IREDELL COUNTY HEALTH DEPARTMENT

IMPROVEMENT PERMIT / AUTHORIZATION TO CONSTRUCT / OPERATION PERMIT / EXISTING SYSTEM INSPECTION

PERMIT# 132420 PIN# 4658051356 DATE 11-23-05

SUBDIVISION Cornelius Estates BLOCK / SECTION ____ LOT 49 LOT AREA .548 Ac SITE CLASS. PS DESIGN FLOW 360 gpd L.T.A.R. .3 gpd/ft²

INITIAL SITE SKETCH

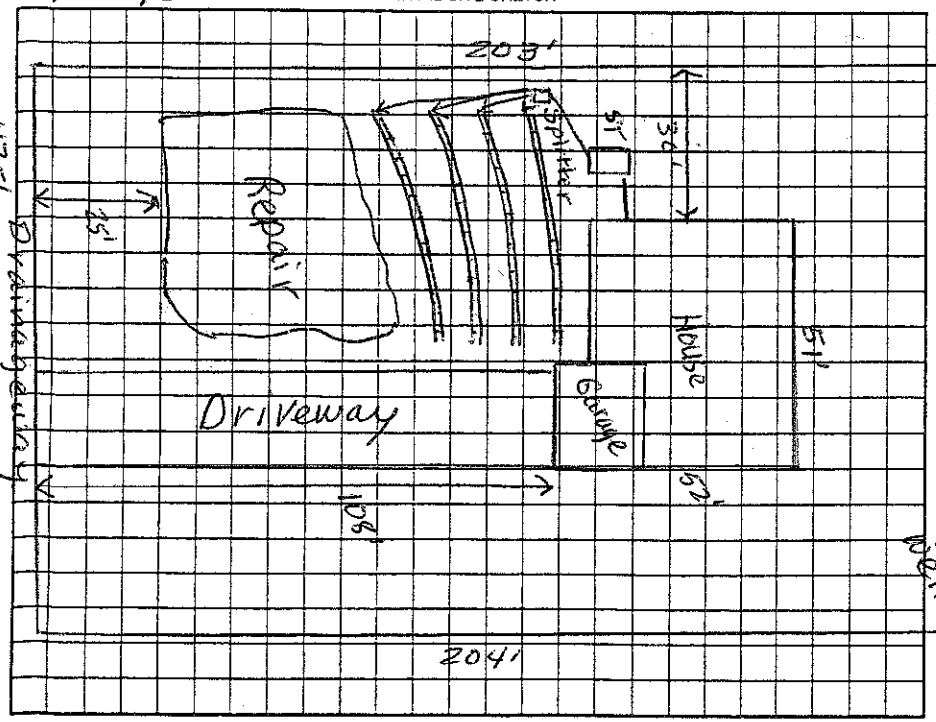
Comments/Conditions: 46 panels
Use Effluent splitter such as Zoehler
Keep system 10' from property line, 5' from garage

AS BUILT SKETCH

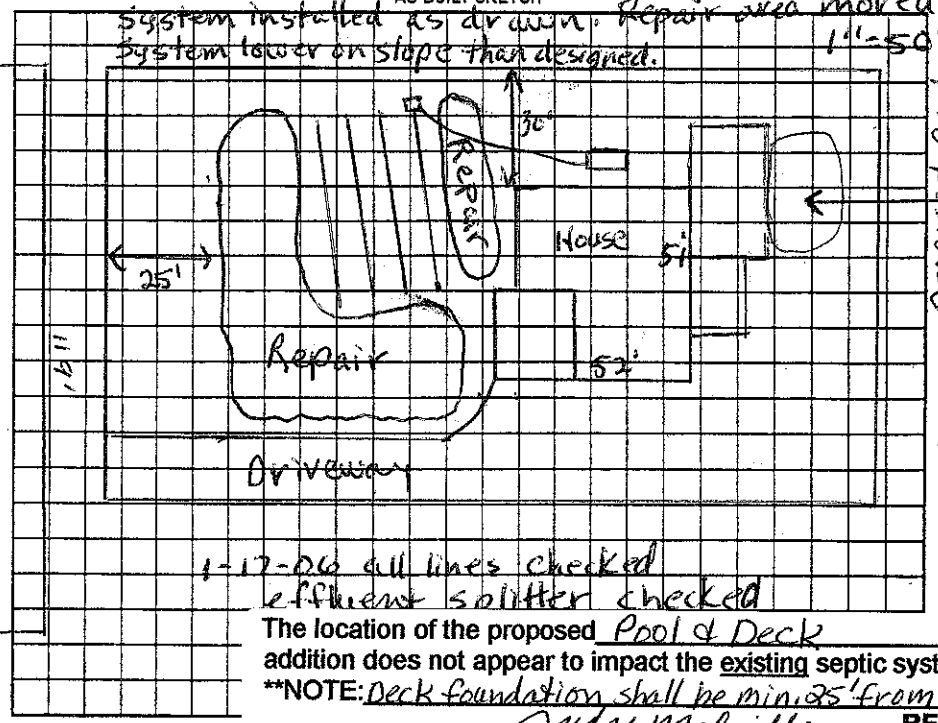
Comments/Conditions: 1-13-05 bottom 2 lines checked 11 panels ea. 50' ea.
JM tank checked - need filter & lines
Blue Polylok filter ~~sand~~ 1-17-06
Septic tank w/ marker
Repair system type changed.

System installed as drawn. Repair area moved.
System lower on slope than designed.

1-17-06 all lines checked
effluent splitter checked

The location of the proposed Pool & Deck addition does not appear to impact the existing septic system.
**NOTE: Deck foundation shall be min. 25' from well
